**APPENDIX A.**  
**NOTICE OF PREPARATION AND RESPONSES**

**Subject:** Notice of Preparation of a Draft Environmental Impact Report for the Tehachapi North Afterbay Project

# Tehachapi North Afterbay Project

Re: The Tehachapi North Afterbay Project  
SCH# 2004061133

Figure 3

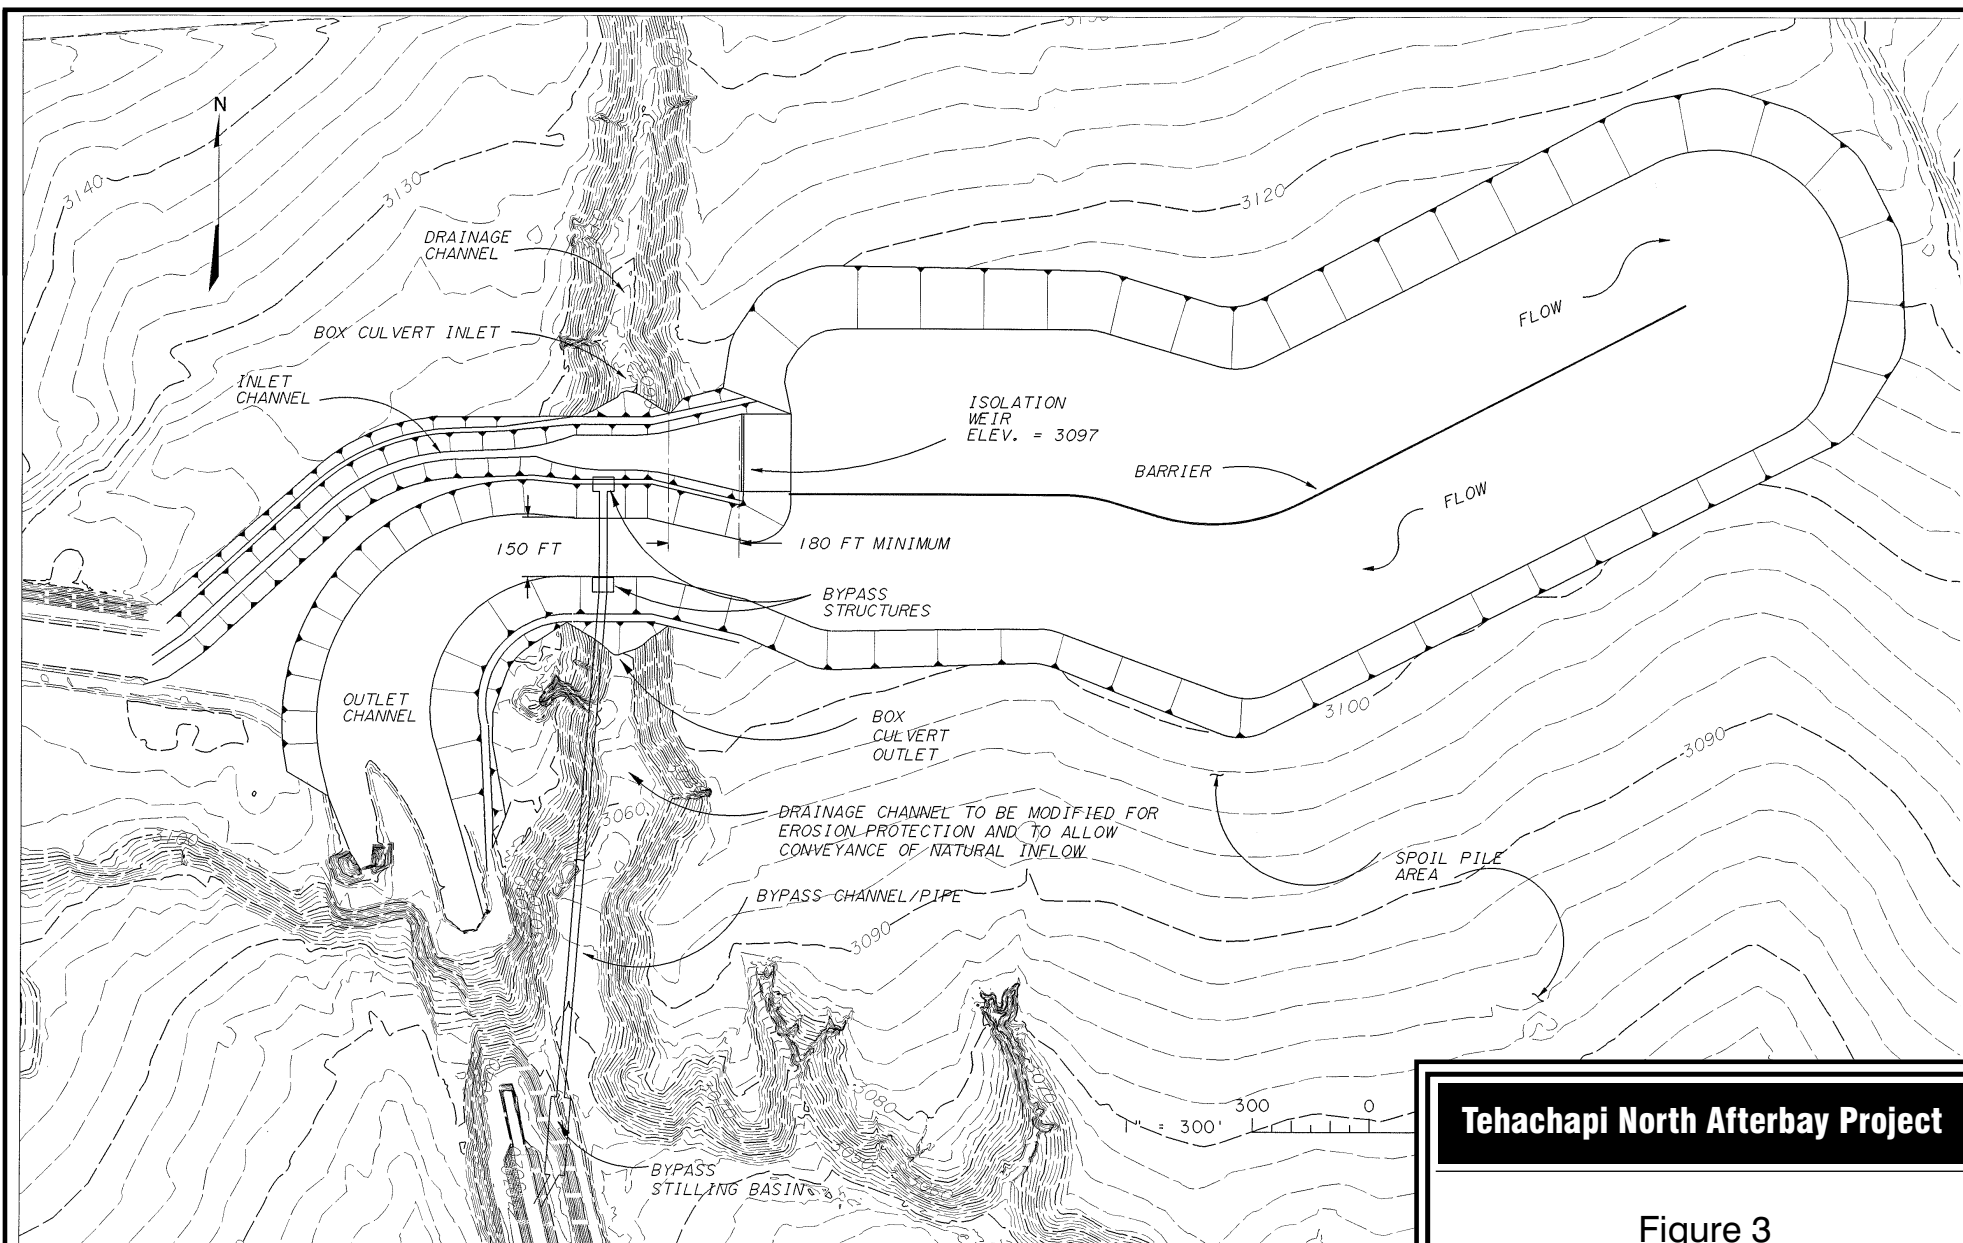
EIR show/discusses contouring grading for this spoil embankment that mimics the existing natural contours.
